## ADDENDUM # 03

Hartsville Middle School  
Auditorium HVAC - Upgrades  
DARLINGTON COUNTY SCHOOL DISTRICT  
JCS PROJECT NO: 22011-A  
September 27, 2022

SHEET NO: **M001**

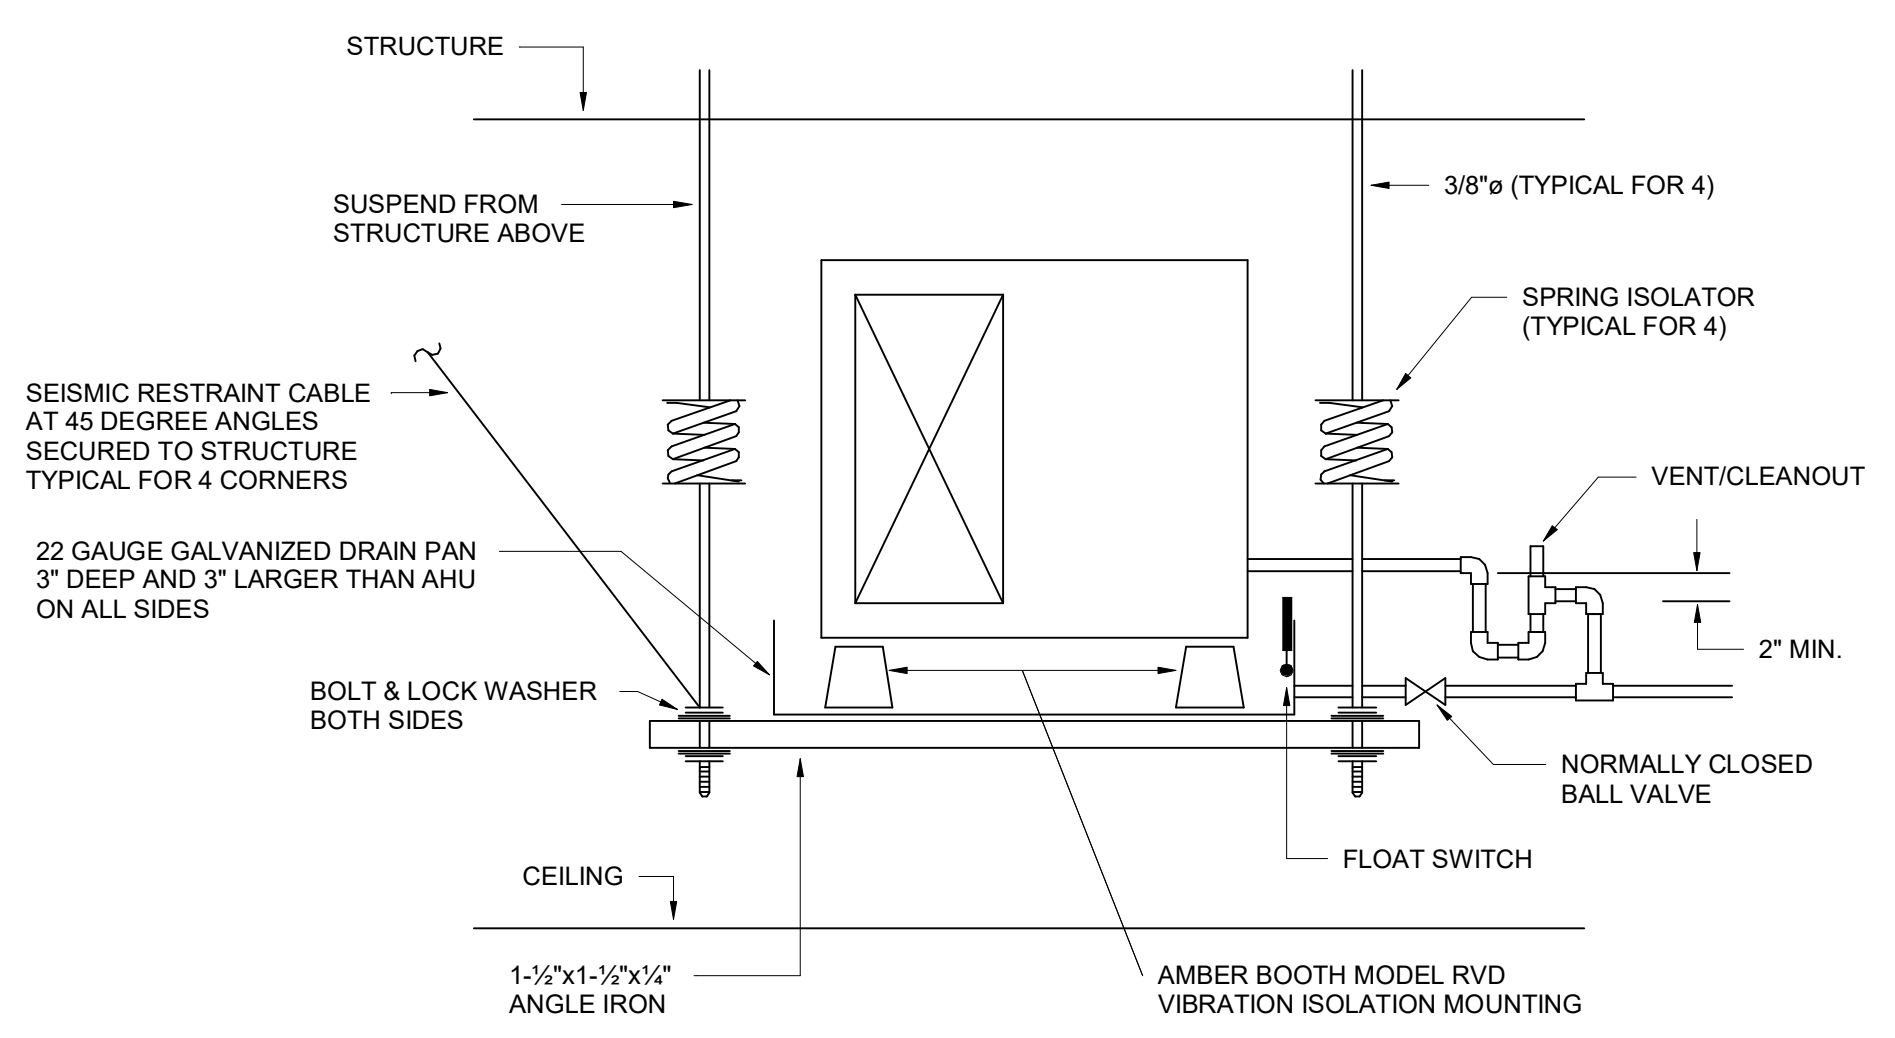
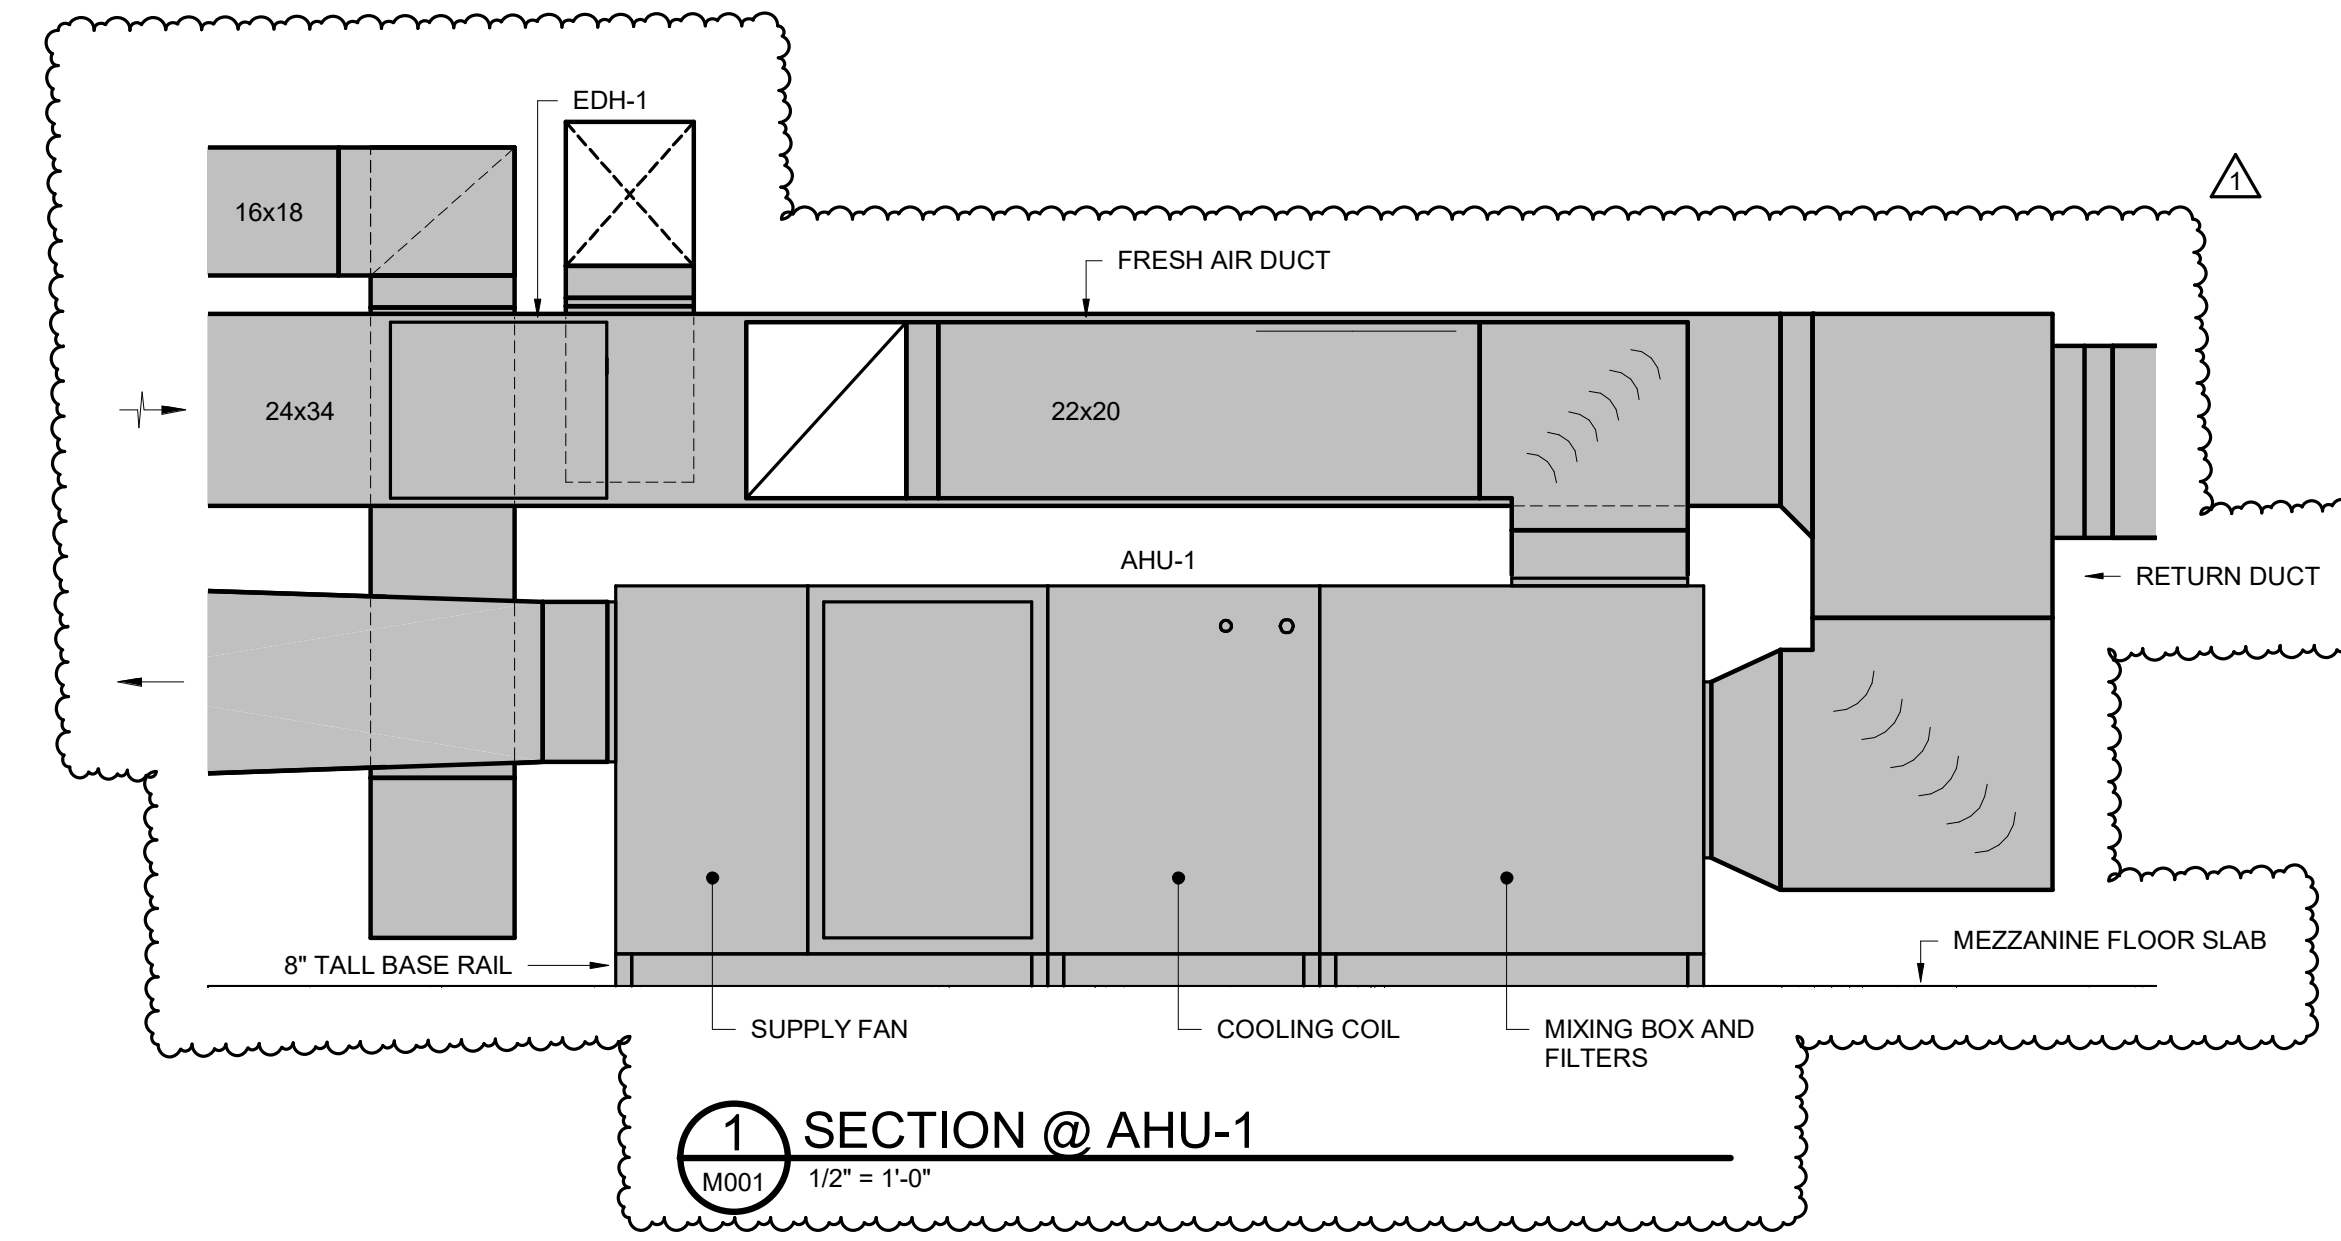
See the attached revised drawings: M-001; M-102; and M-103. Changes are bubbled.

1 FLOOR PLAN - BUILDING 500  
 M102 3/16" = 1'-0"

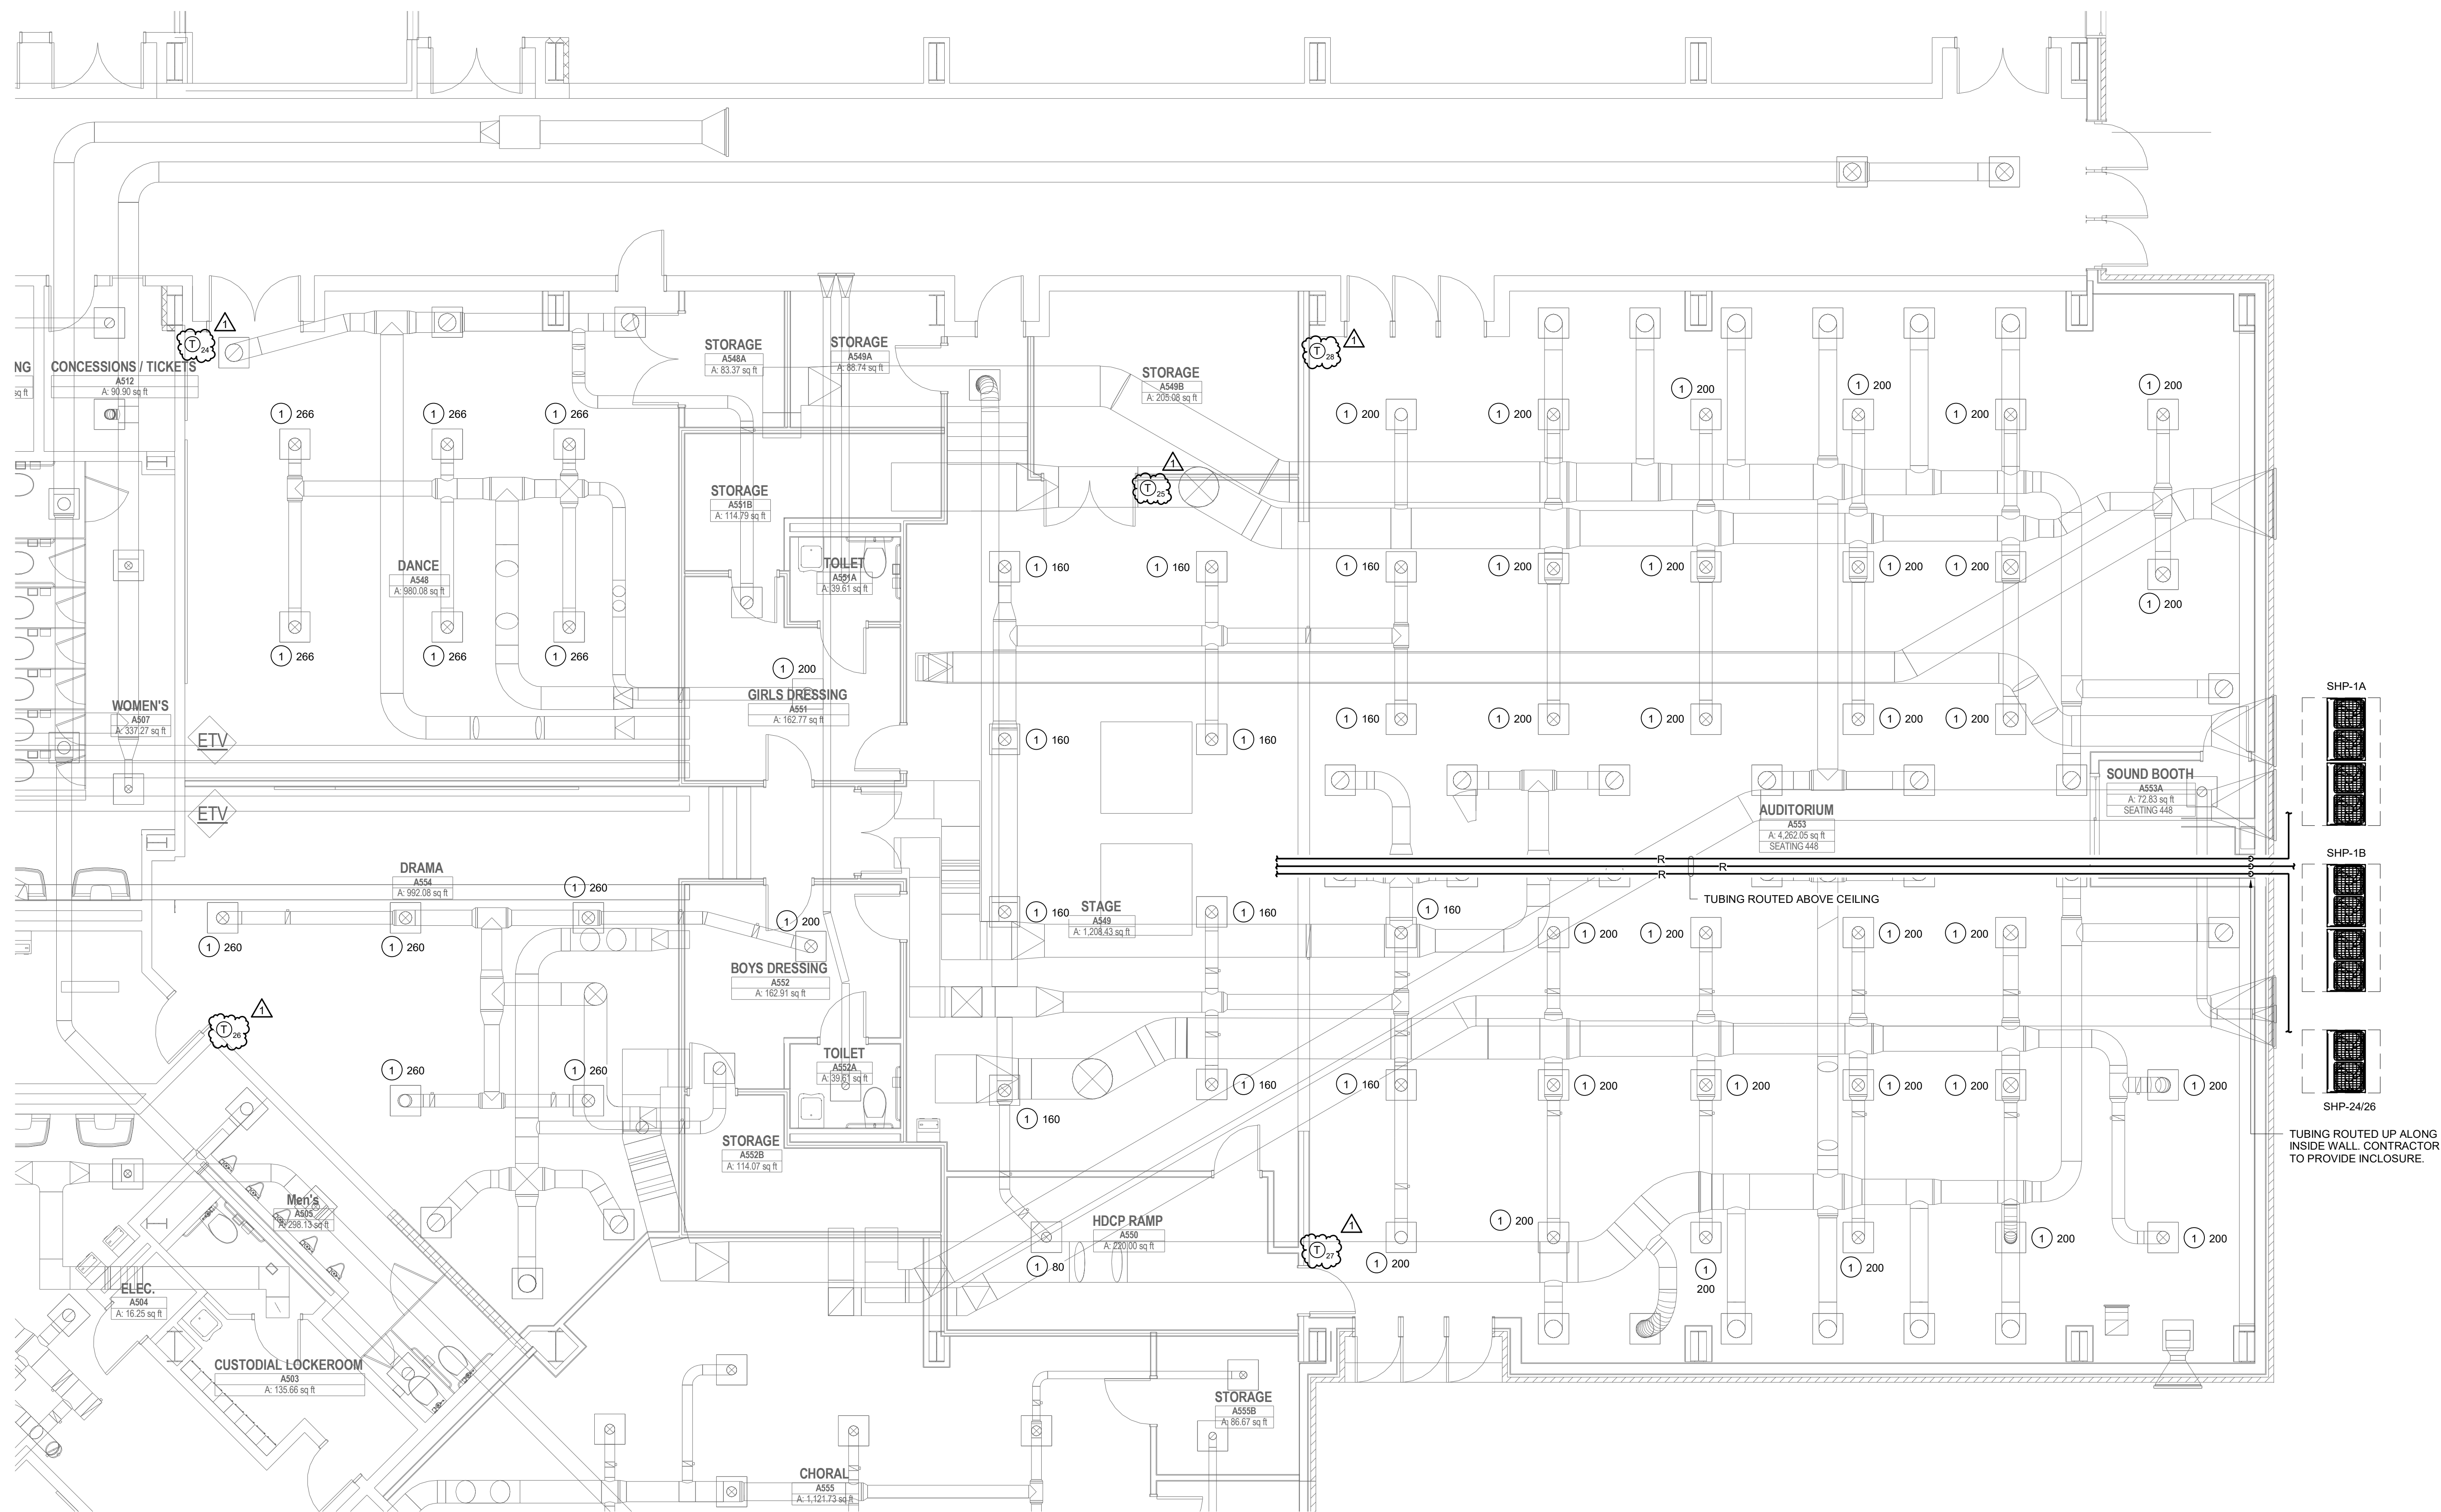
*Question: Where are all of the room sensors to be located? I had the installation guys estimate it at the furthest point from the controlled device so that we would be covered. The locations are not on the drawings.*

**Answer:** The thermostats will be replaced in the existing locations. The location will be shown on the revised drawing. (See attached)
